Addendum No2

HWCDSB - Quote No. 5144

**Exterior Door and Windows**

**ADDENDUM NO.2**

REPLACE MAIN ENTRANCE

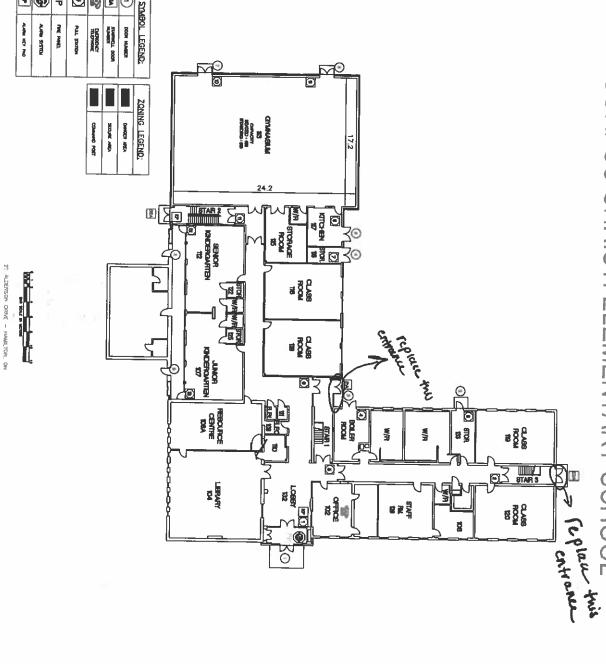
REPLACE ENTRANCE AND GLAZING TO MATCH INCLUDE NEW DOOR HARDWARE CLAZING 1" SEALED UNIT TEMPERED

COORDINATE WITH BOARD CONTRACTOR THE FOLLOWING:
INTERCOM
ELECTRIC STRIKES
KEY FOR ACCESS

ALLOW FOR CONCRETE REPAIRS PRIOR TO RENSTALLATION OF NEW ENTRANCE.
RETURN EXISTING NARDWARE TO BOARD PROJECT MANAGER

INCLUDE ALL INSTALLATION RELATED MATERIALS

# ST. FRANCIS XAVIER ELEMENTARY SCHOOL

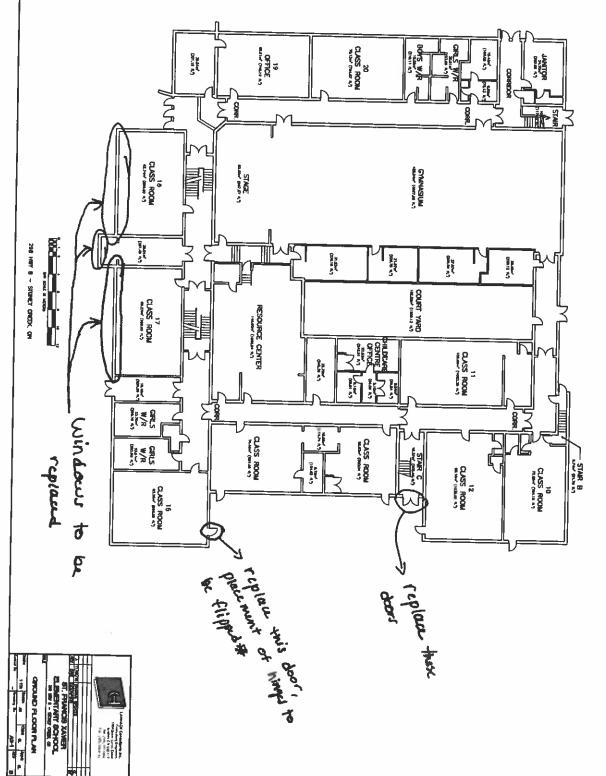
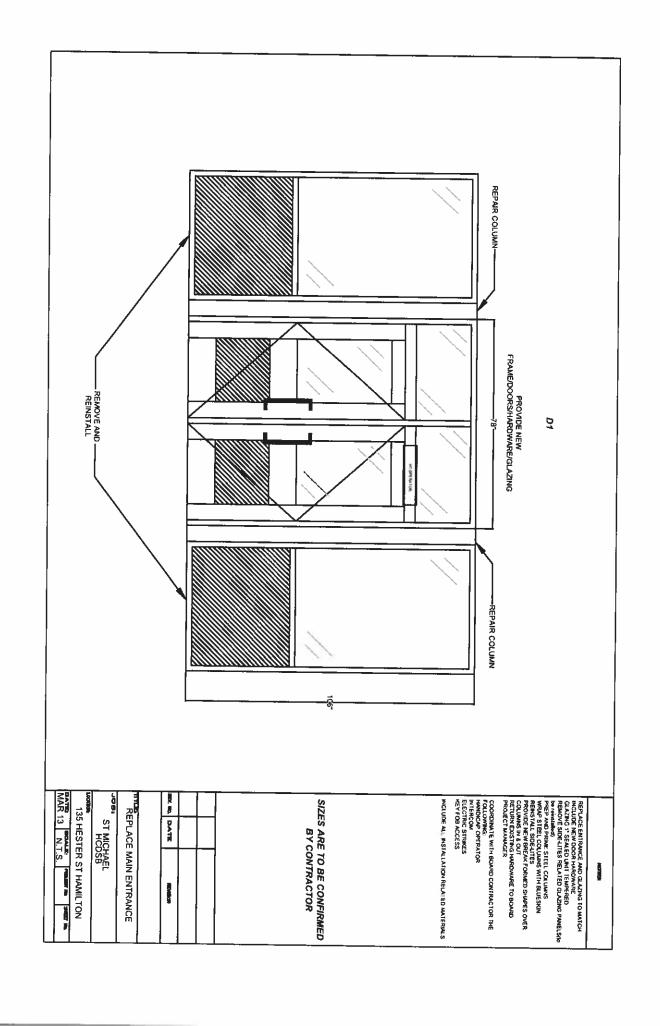
<u>St. Francis Xavier:</u> Replace windows along façade of original building (classroom #17, 18, 24, 25, + work rooms both floors + 2 additional offices not on floor plans + south facing window on second floor). Replace the portion of curtain wall in between ground floor doors & windows above (match existing aluminum). Replace exit doors S1C & 3.

## ST. MICHAEL ELEMENTARY SCHOOL

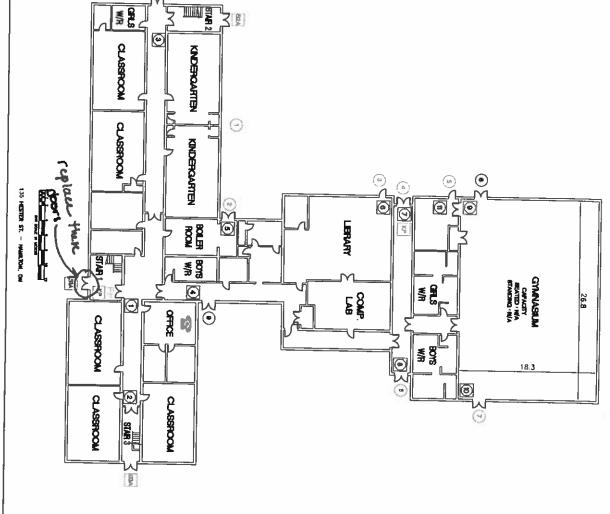
### St. Michael: Replace main entrance doors.

- Take out existing window frames on either side of columns. Wrap columns with Blue skin & coat columns, cap with aluminum flashing. Reinstall existing window frames, make good. Remove & dispose of existing aluminum entrance doors. Existing door hardware to be removed and handed back to board for use elsewhere. Replace aluminum entrance doors (specifications followed below). New door hardware to match what is existing onsite.
- Medium stile non thermally broken clear anodized aluminum doors 1 ¾" thick.
- 6mm temp/ argon low 'e' Energy advantage glass.
